BUREAU OF PLANNING AND ZONING

May 29, 2019

RE: (19-006LD) – 19050001 – Valley Park Apartments Land Development Plan - 2250 Catasauqua Road - Ward 13, Zoned RG, Plan dated May 2, 2019.

Turning Performance Analysis

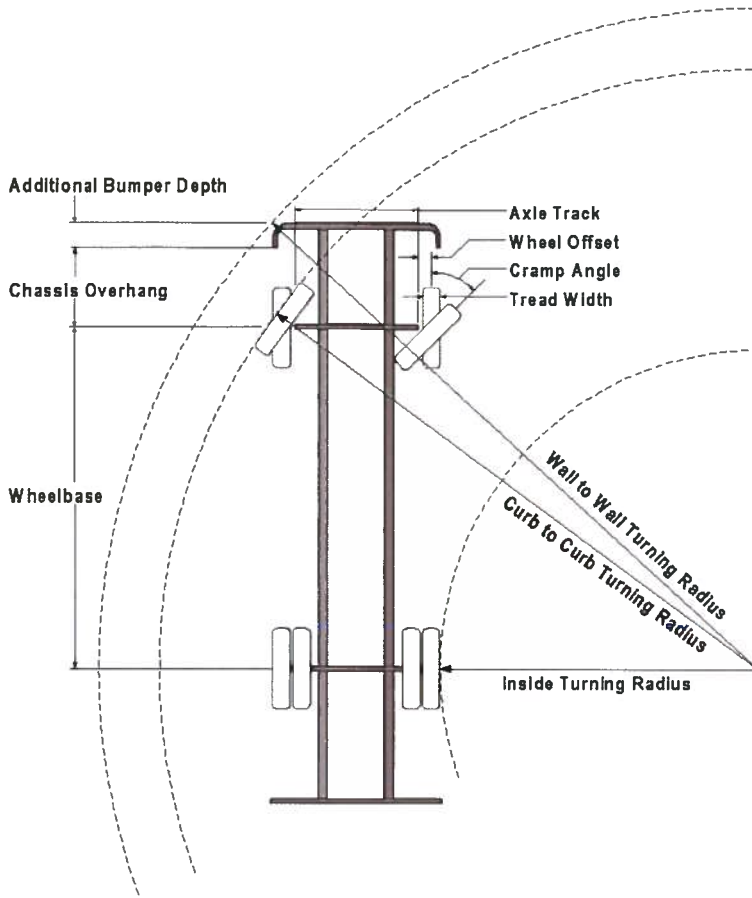
1. The architect/engineer must confirm Fire Department vehicles have the required turning space to access all areas. (See attached turning radius information for our largest vehicle.) Please submit a turning plan.
